## SERVICE INFORMATION BULLETIN

**APPLICABILITY:** 2017-2018MY Impreza  
2018MY Crosstrek

**NUMBER:** 07-129-18R

**SUBJECT:** Inaccurate Tire Pressures  
Displayed in Combination Meter

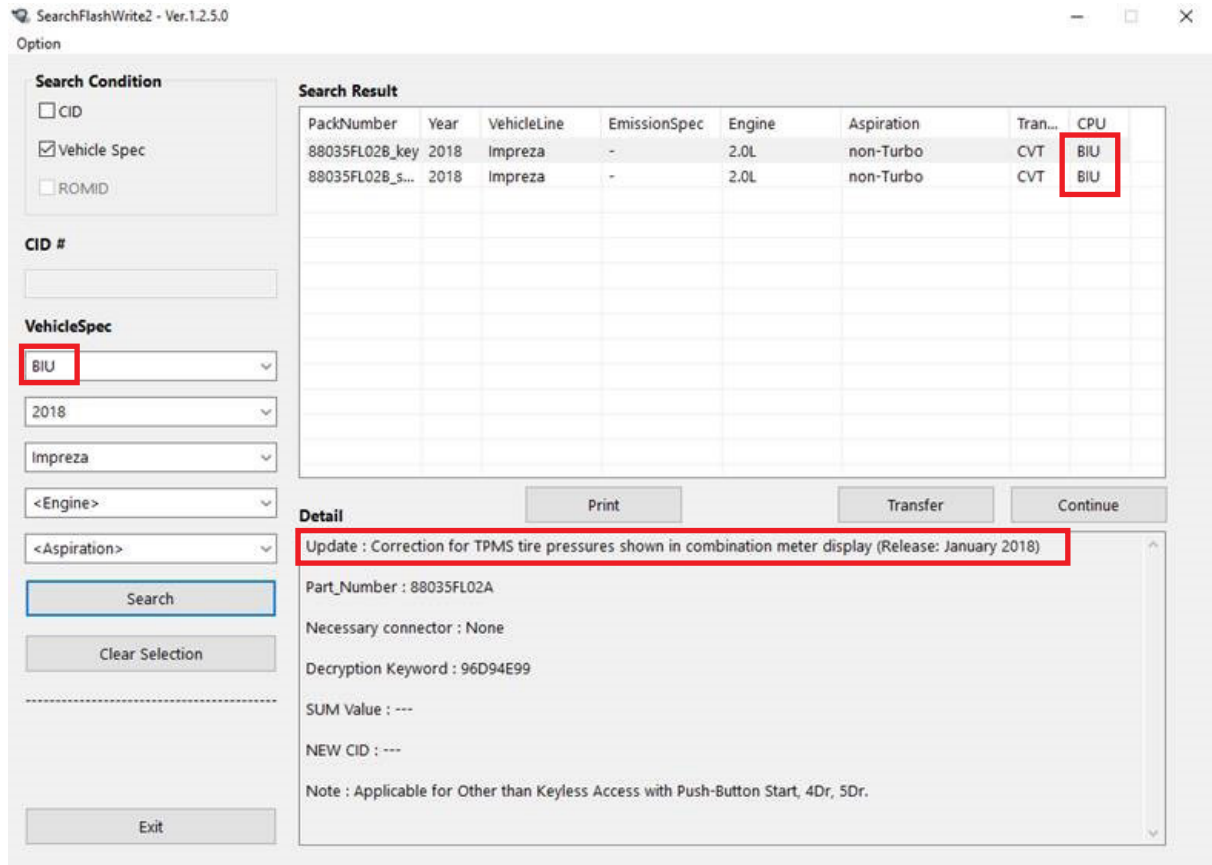
- Always confirm (and correct as necessary) all tire pressures before performing this reprogramming.
- To correct the TPMS display function, reprogramming of the **Body Integrated Unit (BIU)** will be required. A screen shot of the FlashWrite Search Condition display is provided below. From the Search FlashWrite2 screen, select **BIU** from the ECM drop down menu.

- Reprogram the **BIU** following the normal FlashWrite procedure.
